Project	**IEEE 802.16 Broadband Wireless Access Working Group <http://ieee802.org/16>**
Title	**Using the lists of IP / MAC addresses in the Packet Classifier Rule Tables**
Date Submitted	**2005-04-21**
Source(s)	Joey Chou [mailto:joey.chou@intel.com] Intel Corporation 5000 W. Chandler Blvd. Chandler, AZ 85226
Re:	
Abstract	This contribution proposed the tables of supporting the lists of IP / MAC address and Port be added to the Packet Classifier Rules in IEEE P802.16f/D3.
Purpose	Adoption
Notice	This document has been prepared to assist IEEE 802.16. It is offered as a basis for discussion and is not binding on the contributing individual(s) or organization(s). The material in this document is subject to change in form and content after further study. The contributor(s) reserve(s) the right to add, amend or withdraw material contained herein.
Release	The contributor grants a free, irrevocable license to the IEEE to incorporate material contained in this contribution, and any modifications thereof, in the creation of an IEEE Standards publication; to copyright in the IEEE's name any IEEE Standards publication even though it may include portions of this contribution; and at the IEEE'

Figure 3: New wmanIfBsClassifierRuleTable

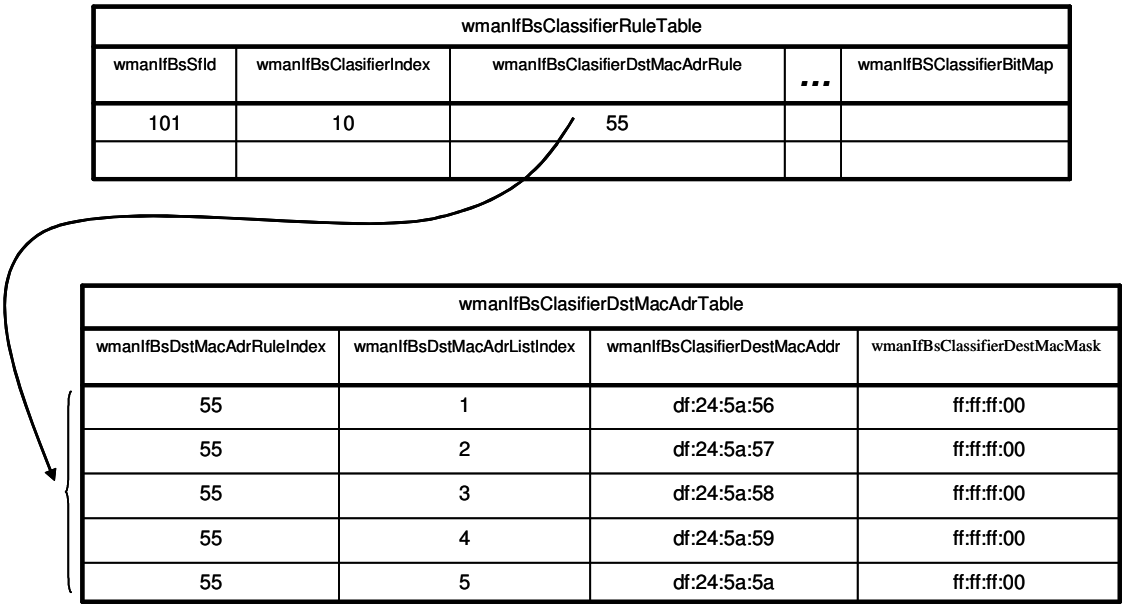
wmanIfBsClassifierRuleTable and wmanIfCmnClassifierRuleTable in current 802.16f define these rules as the scalar objects. Although there is a workaround, as shown in Fig 2, where a list of destination MAC addresses and masks are stored in multiple entries of the classification rule table, this is not an efficient implementation, since there has to be one rule for each destination MAC addresses and masks with all other fields empty. This implementation will also increase the size of classification rule table, especially in the BS.

Fig 3 shows an example of this proposal. A new table – wmanIfBsClasifierDstMacAdrTable – is created to store the list of destination MAC addresses and MAC address mask. This list is identified by wmanIfBsDstMacAdrRuleIndex that can be referred by wmanIfBsClasifierDstMacAdrRule in the wmanIfBsClassifierRuleTable. Each element in the list is identified by wmanIfBsDstMacAdrListIndex.

This contribution proposes the following:

- Remove the following tables from IEEE P802.16f/D3
  - wmanIfBsClassifierRuleTable
  - wmanIfCmnClassifierRuleTable
- Add the following tables, as defined in section 2, to IEEE P802.16f/D3
  - wmanIfBsClasifierRuleTable
  - wmanIfBsClasifierSrcIpAdrTable
  - wmanIfBsClasifierDstIpAdrTable
  - wmanIfBsClasifierSrcIpPortTable
  - wmanIfBsClasifierDstIpPortTable
  - wmanIfBsClasifierSrcMacAdrTable
  - wmanIfBsClasifierDstMacAdrTable
  - wmanIfCmnClasifierRuleTable
  - wmanIfCmnClasifierSrcIpAdrTable
  - wmanIfCmnClasifierDstIpAdrTable
  - wmanIfCmnClasifierSrcIpPortTable
  - wmanIfCmnClasifierDstIpPortTable
  - wmanIfCmnClasifierSrcMacAdrTable
  - wmanIfCmnClasifierDstMacAdrTable
